Model: PRIORT PINKGOLD		Date: 20-May-02	No: R-C238-001
Subject: PINKGOLD firmware history		Prepared by: H. Onodera, Priort Service Planning Section	
Classification: <input type="checkbox"/> Troubleshooting <input checked="" type="checkbox"/> Part information <input type="checkbox"/> Action required <input type="checkbox"/> Mechanical <input type="checkbox"/> Electrical <input type="checkbox"/> Service manual revision <input type="checkbox"/> Paper path <input type="checkbox"/> Transmit/receive <input type="checkbox"/> Retrofit information <input type="checkbox"/> Other ()			
Model Name: Ricoh JP3000/JP3800, Gestetner 5430/5428C, RexRotary 1330, nashuatec CP430, Savin 3260DNP, Standard SD370

This bulletin is to inform you of the firmware modification history of Priort PINKGOLD.

Model: PRIPORT PINKGOLD		Date: 20-May-02	No: R-C238-002
Subject: Image shift problem		Prepared by: H. Onodera, Priport Service Planning Section	
Classification:	<input checked="" type="checkbox"/> Troubleshooting <input type="checkbox"/> Part information <input type="checkbox"/> Action required <input type="checkbox"/> Mechanical <input type="checkbox"/> Electrical <input type="checkbox"/> Service manual re

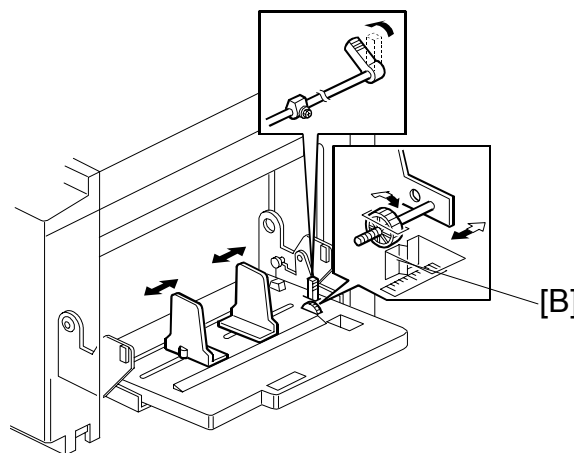
The image shifts approximately 7mm when the side fence friction pads [A] are used.

The area that the image scanning system reads is determined by the size detected in the paper tray (not by an original detection sensor). However, the machine does not adjust for the thickness of the side pads. As a result, the machine then scans an area larger than the paper's actual size, shifting the image writing start position with respect to the paper edge.

1. The width of the pads has been decreased (see MB #MC238001).
2. Main firmware suffix D has been modified so that the machine takes into account the thickness of these new pads – i.e. size detection range has been increased (see RTB #RC238001 and Table 2 below).

The basic solution is to remove the pads, since they are normally not needed (see PINKGOLD Manual, p.6-34). However if the pads are being used to prevent multi-feeds, please do one of the following:

C238A085.WMF

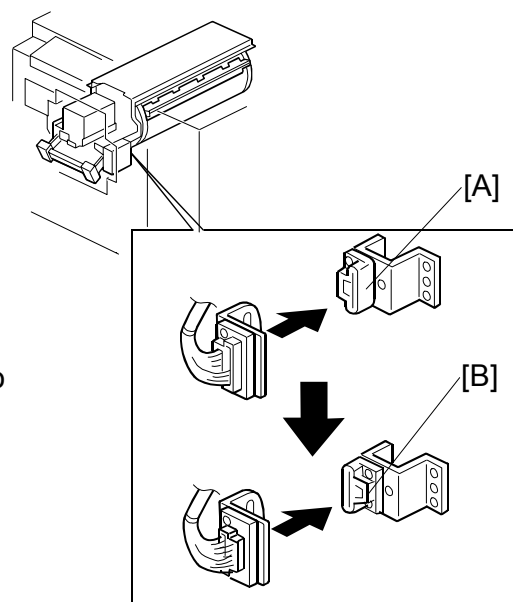
Only B4 drums can be installed on the PG B4. The direction of the connector has been changed from [A] to [B] as shown, so that the A3/A4 drums used on the PINKGOLD cannot be installed on the PG B4.

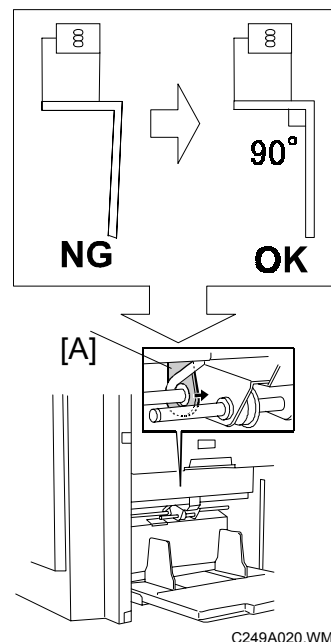
A bent retainer [A] causes extra play in the bushing/roller shaft connection, which can cause the bushing to come loose.

NOTE: If this does not solve the problem, replace the Sleeve with P/N #07078105B (see MB #MC238011).

Installing the C2389000 Spacer

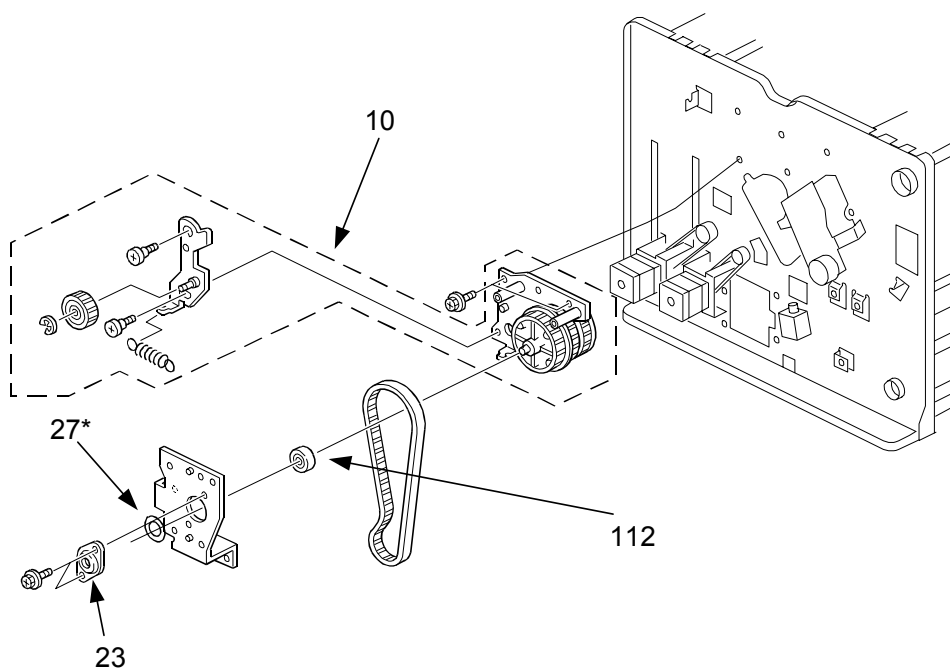
Three spacers added, as described in MB #MC238024.

1. Remove the Rear Cover.
2. Remove the Bearing Holder (#23).
3. Attach the Spacer (#27*) together with the Bearing Holder (#23).

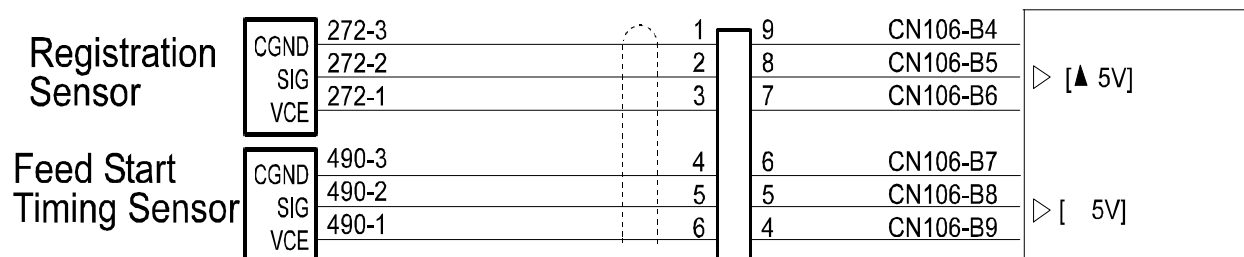
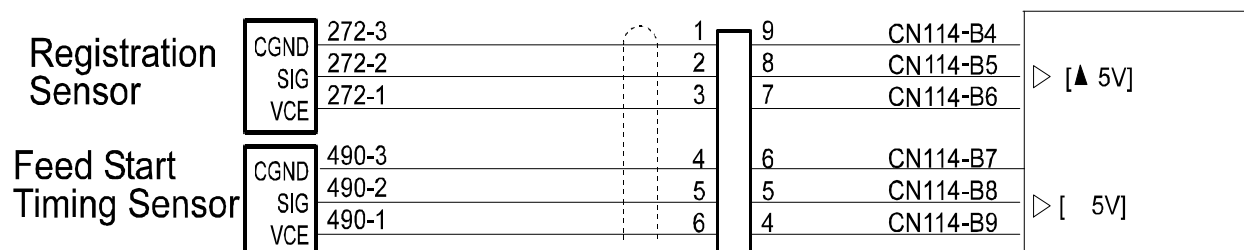
● Incorrect:

Registration and feed start timing sensors shown going to **CN 106** on the MPU.

● Correct:

Both sensors go to MPU **CN114**.

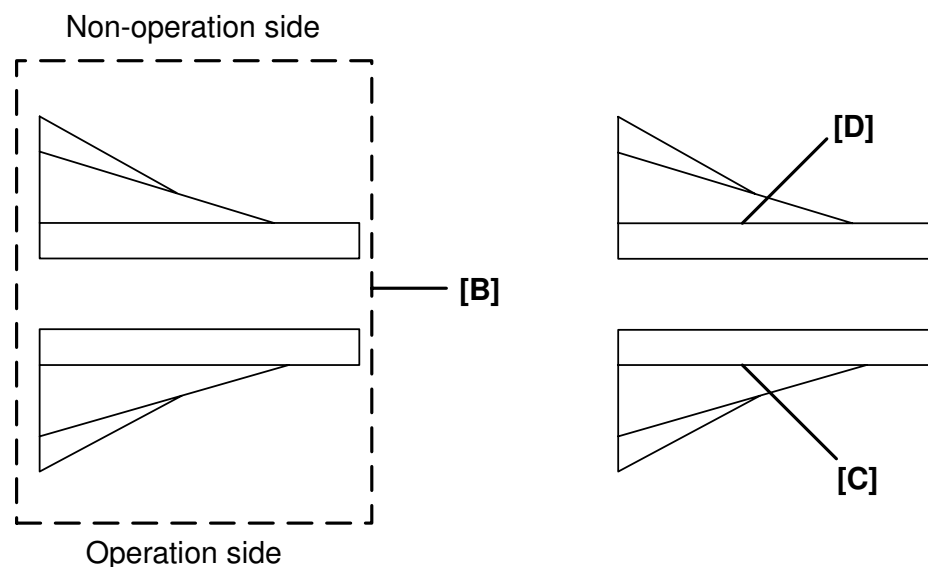
The shapes of the air knife fan, fan bracket and delivery belt have been changed to ensure the proper paper delivery.

Note: This modification applies only to the models listed in **MB #MC238031**.

Installing the C2389002 Metal Wing Set

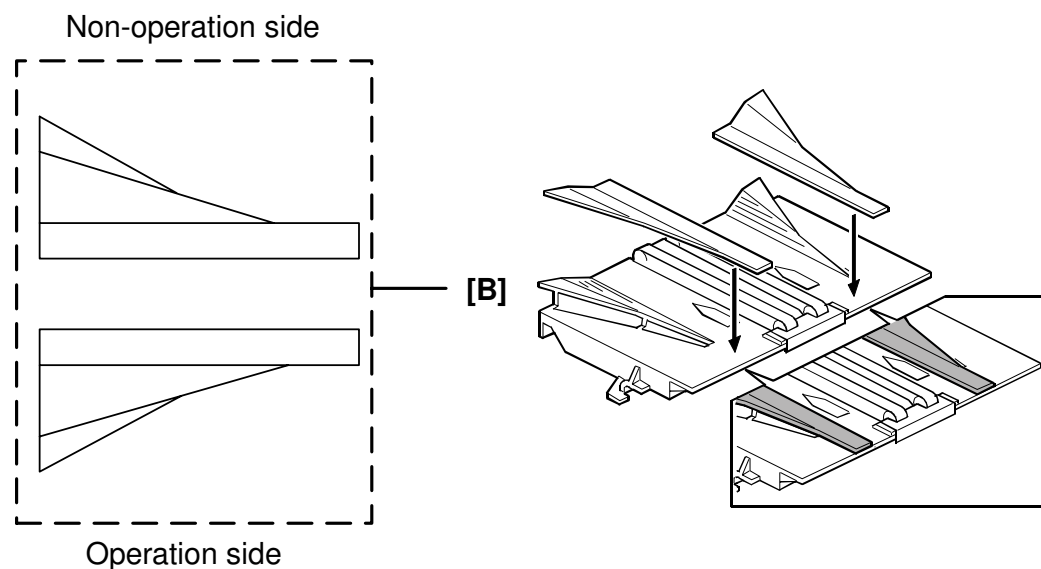
- 1) Replace the parts with the modified ones, OR
- 2) Install the metal wing set shown below.

1. Remove the paper delivery cover.
2. Remove the paper delivery unit.
3. Clean the paper delivery unit with isopropyl alcohol.
4. Peel off the double-sided tape and blue vinyl covering on the metal wings.
5. Attach the wings as shown above.

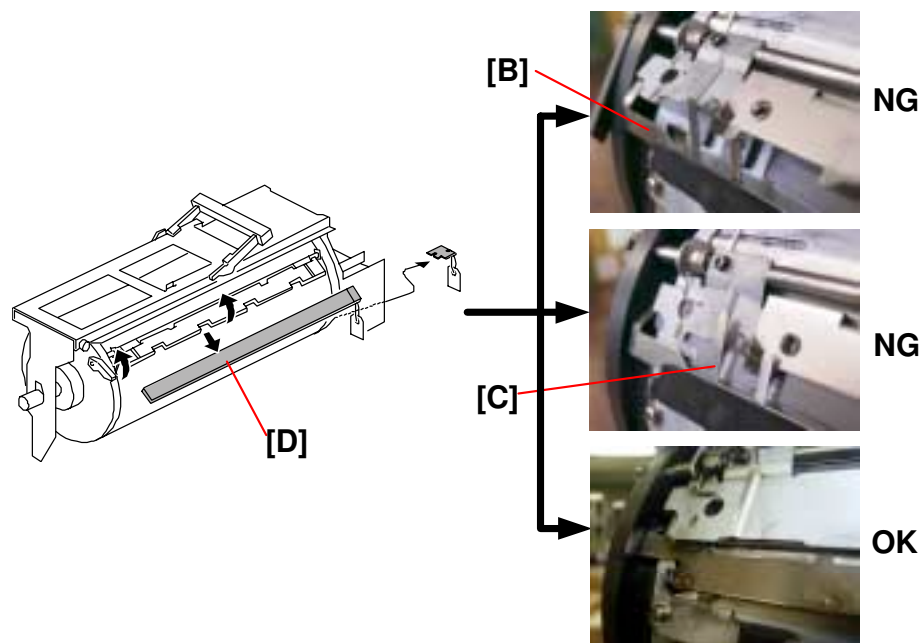
2. The master clasper [B], [C] is set in the wrong direction when the filament tape [D] is removed at machine installation.

Note: Incorrect = The clasper's lower teeth are on the outside.

- The new firmware automatically opens/closes the clasper at certain times to make sure it stays closed in the correct position.
- For details, see RTB #RC238011b.

Fig. 1: Correct

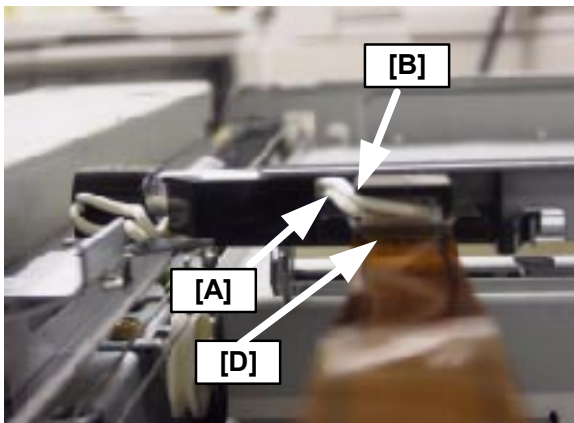
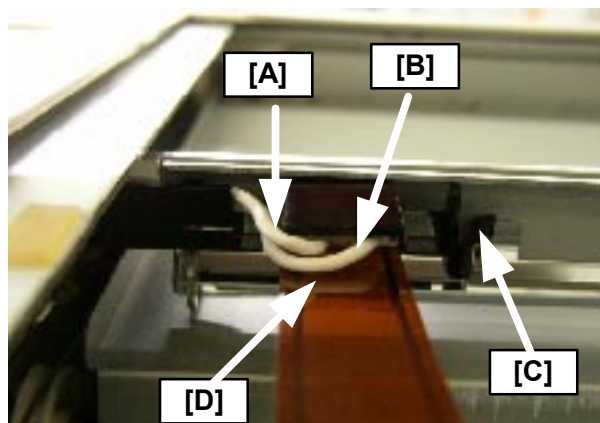
Correct (Fig. 1): Wire [A] is led under wire [B], and they are not touching the flexible cable.

2. Check the position of wire [A] and wire [B] for the flexible cable.
 - If the wires are like in "Fig. 1: Correct," stop this procedure. There is no problem.

- If the wires are like "Fig. 2: Incorrect", go to Step 3.
3. Turn OFF the main switch.
4. Remove the exposure glass.
5. Check the flexible cable [D].
 - If you see any damage to the outside of the flexible cable, replace it.

6. Push the pick [C] to the left to remove the Harness Guide [E] for the flexible cable.
7. Put wire [A] and wire [B] in the same position as "Figure 1: Correct."
